ADDENDUM NO. 1
TO
BRO-B057(20)
5th STREET OVER PAGE BRANCH
BRIDGE NO. 1315001
LINCOLN COUNTY, MO

December 10, 2020

BRO-B057(20)
BRIDGE NO. 1315001

SHEET NO.
7 OF 21

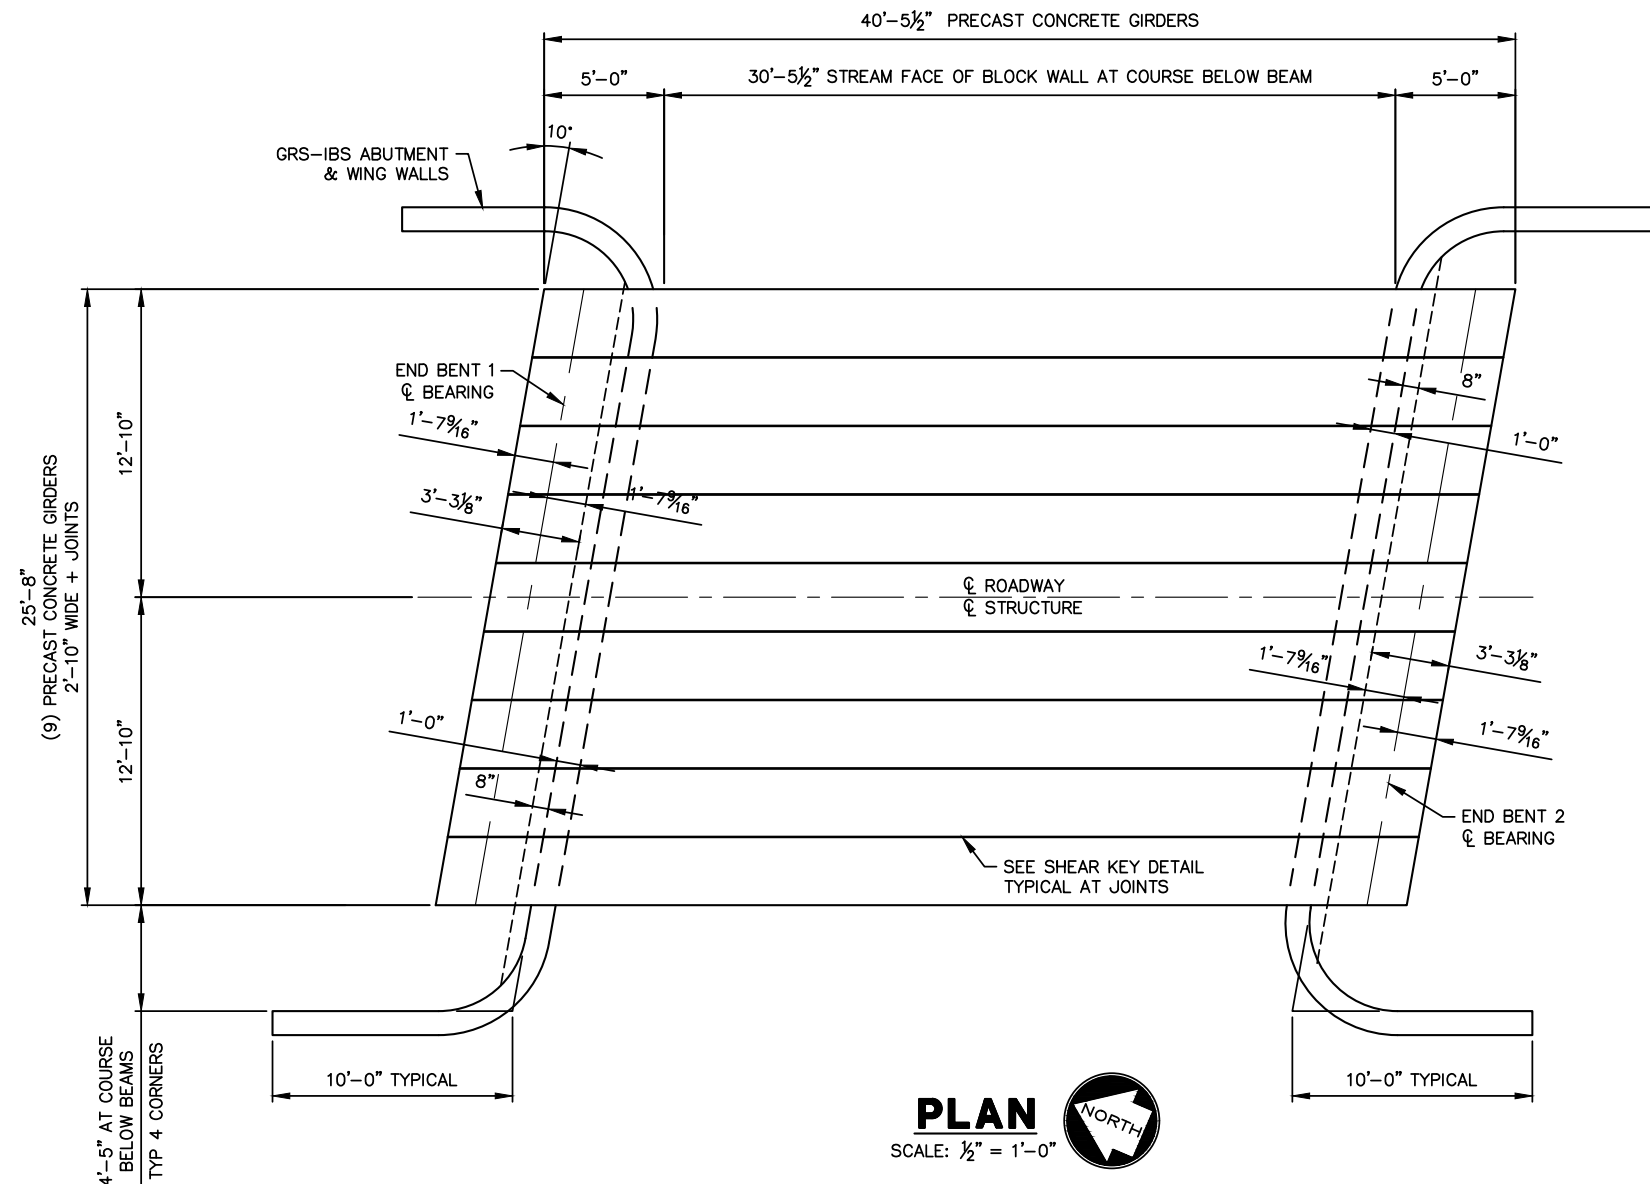
- a. Plan Sheet 7 of 21, Note 11: 15" is to change to 18"
 - b. Plan Sheet 9 of 21, vertical dimension of Typical Section of Girder: 1'3" is to change to 1'6"

- a. Plan Sheet 7 of 21: Bid Item #28 will change from "Reinforcing Steel" to "Epoxy Coated Reinforcing Steel"
 - b. Itemized Proposal:
 - i. Bid Item Bid Item #28 will change from "Reinforcing Steel" to "Epoxy Coated Reinforcing Steel"

- a. Plan Sheet 7 of 21:
 - i. Bid Item #31 "GRS-IBS Fabric" quantity is to be 1354 S.Y.
 - ii. Bid Item #32 "GRS-IBS Reinforced Backfill (3/4" Clean)" quantity is to be 250 C.Y.

Epoxy Coated Reinforcing Steel

1354

250

BENT 1 GRS-IBS WALL
ELEVATIONS

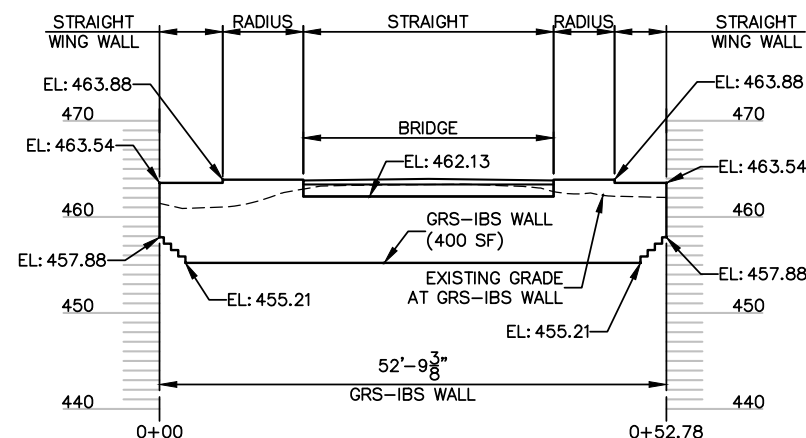
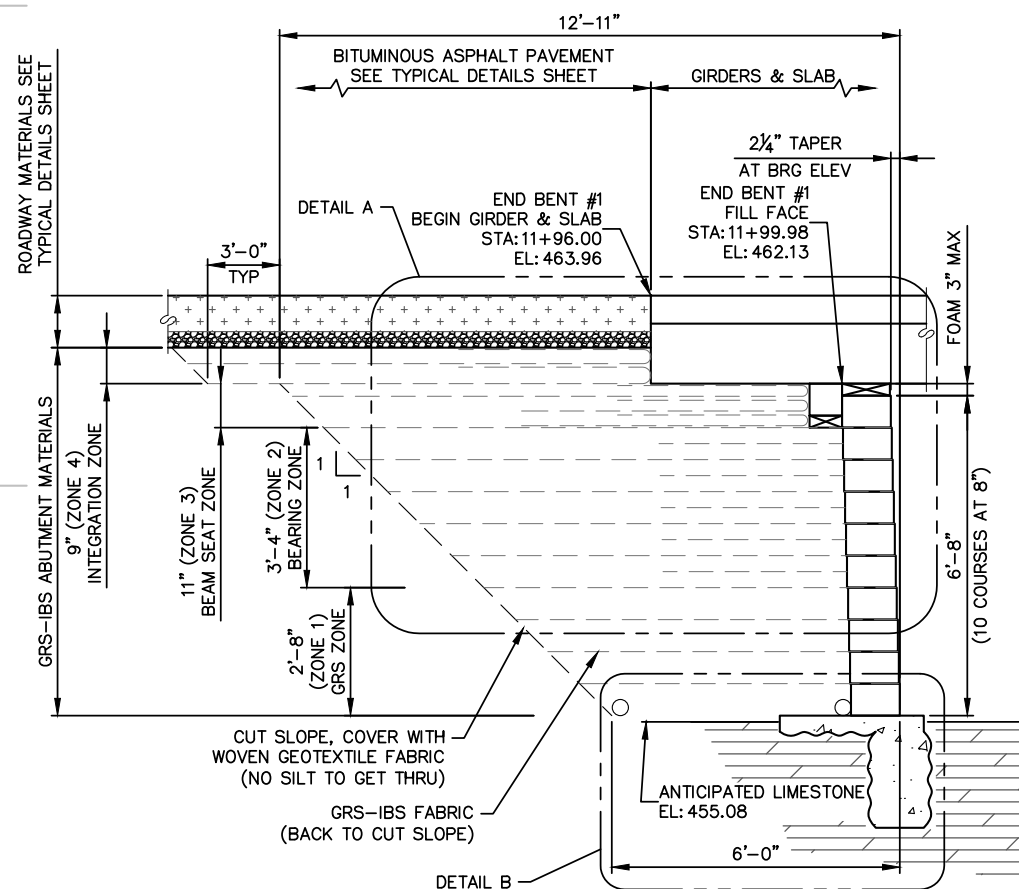
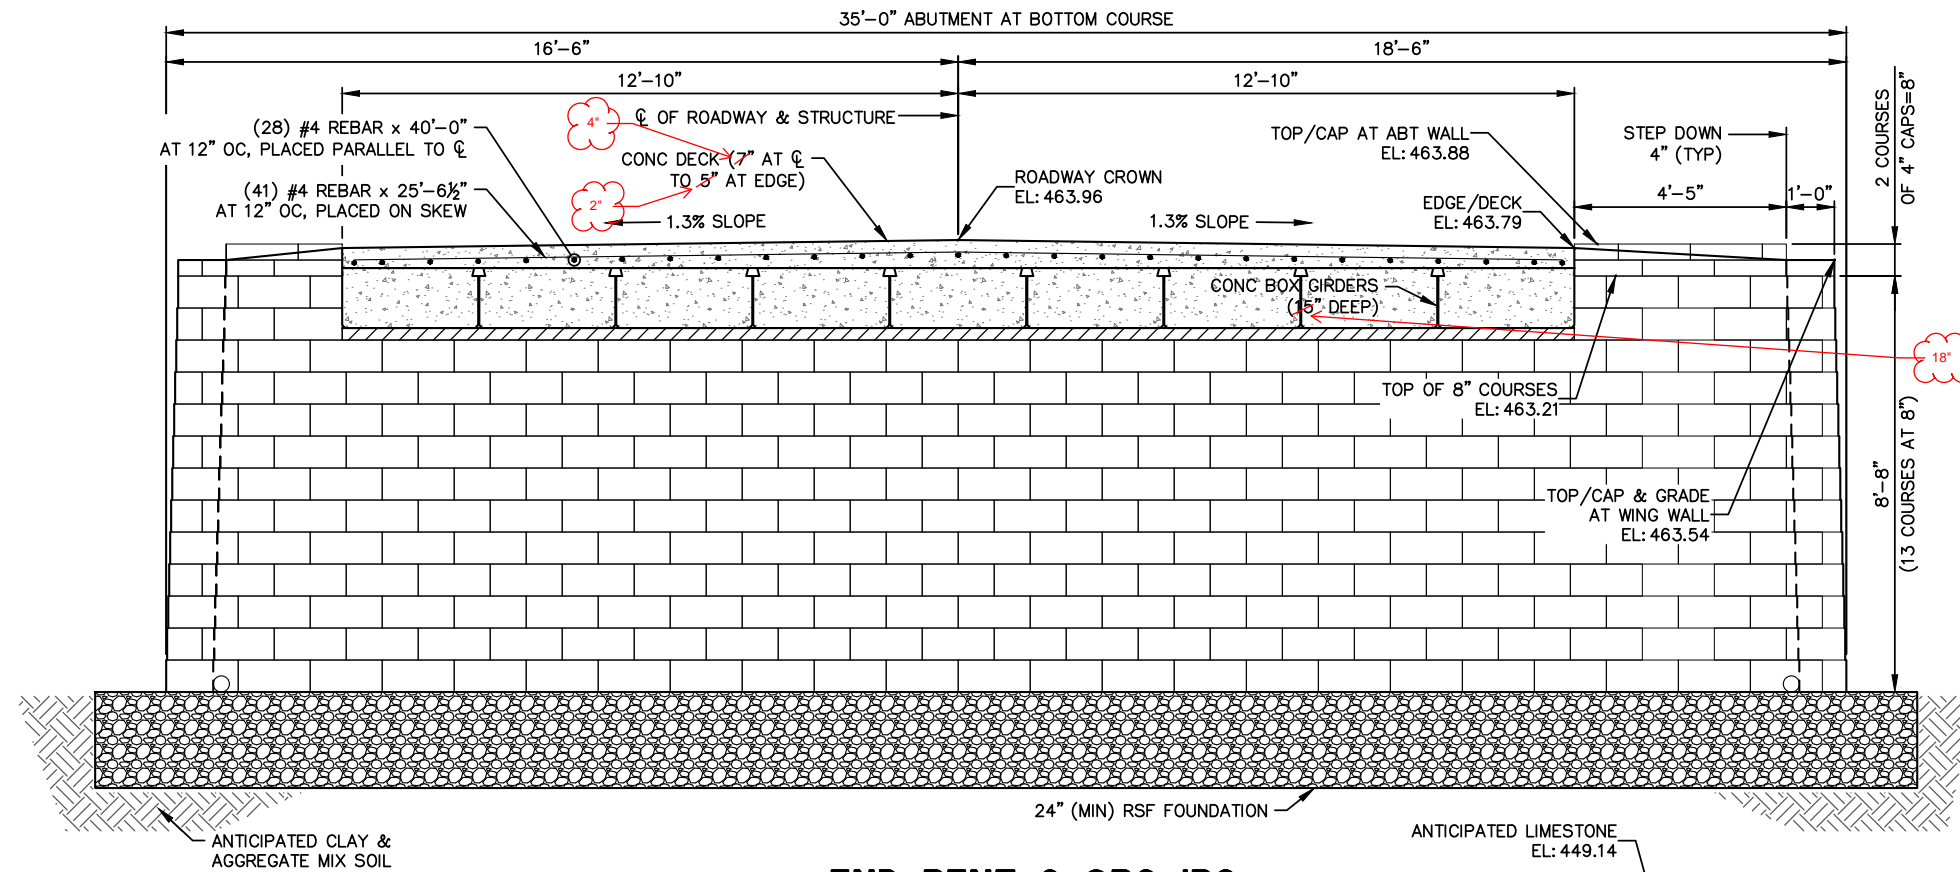
- c. Plan Sheet 11 of 21
 - i. Callout "Concrete Deck (7" at centerline to 5" at edge)" is to change to Concrete Deck (4" at centerline to 2" at edge)
 - ii. Callout "Conc Box Girders (15" Deep)" is to change to "Conc Box Girders (18" Deep)"

BENT 2 GRS-IBS WALL
ELEVATIONS

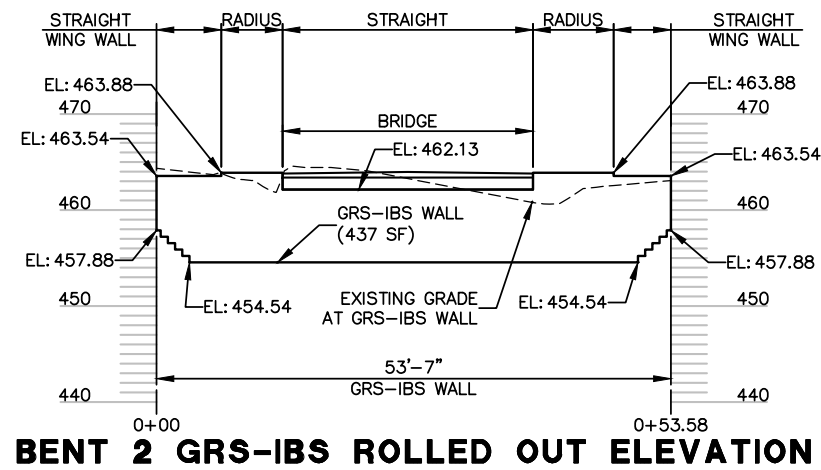
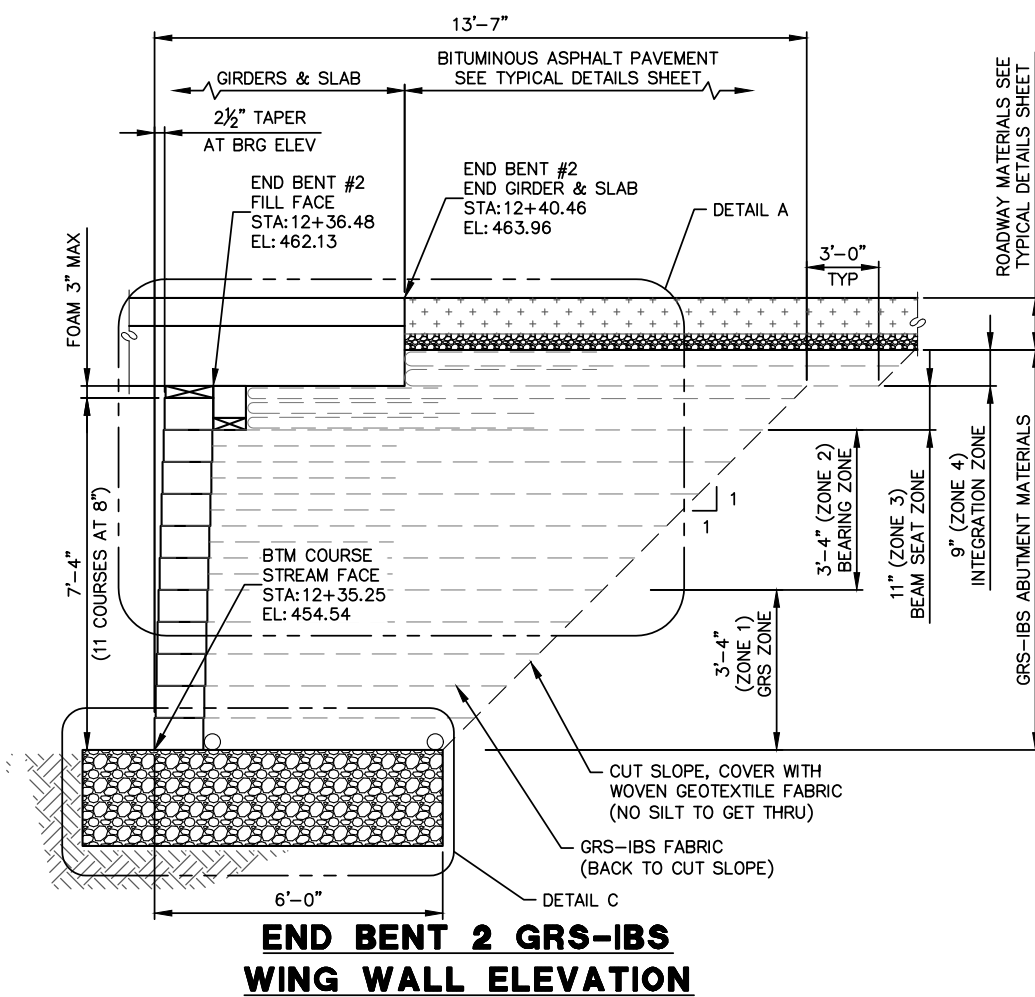
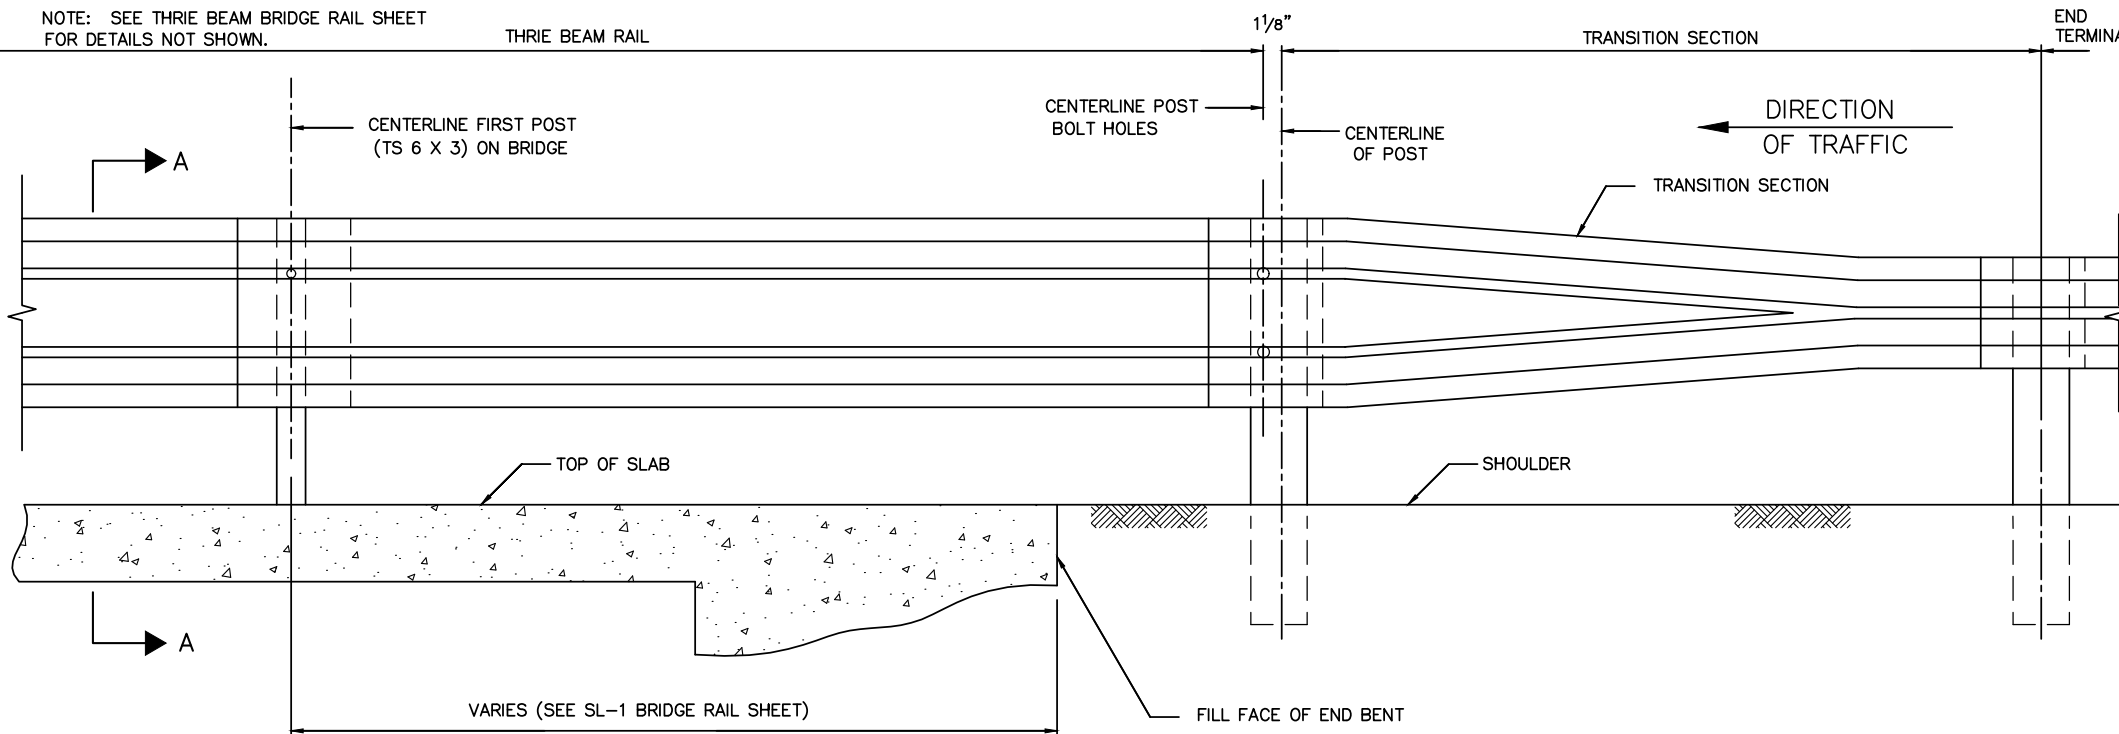
- d. Plan Sheet 12 of 21
 - i. Callout "Concrete Deck (7" at centerline to 5" at edge)" is to change to Concrete Deck (4" at centerline to 2" at edge)
 - ii. Callout "Conc Box Girders (15" Deep)" is to change to "Conc Box Girders (18" Deep)"

DETAIL AT SLAB

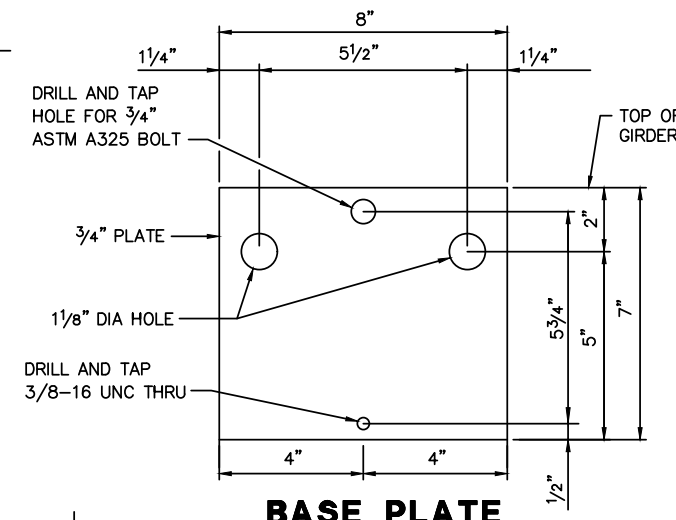
- e. Plan Sheet 16 of 21, Detail at Slab Drawing: Callout "TS 6"x3"x1/4"x3'9" (8'4" max spacing)" is to change to "TS 6"x3"x1/4"x3'6" (8'4" max spacing)"
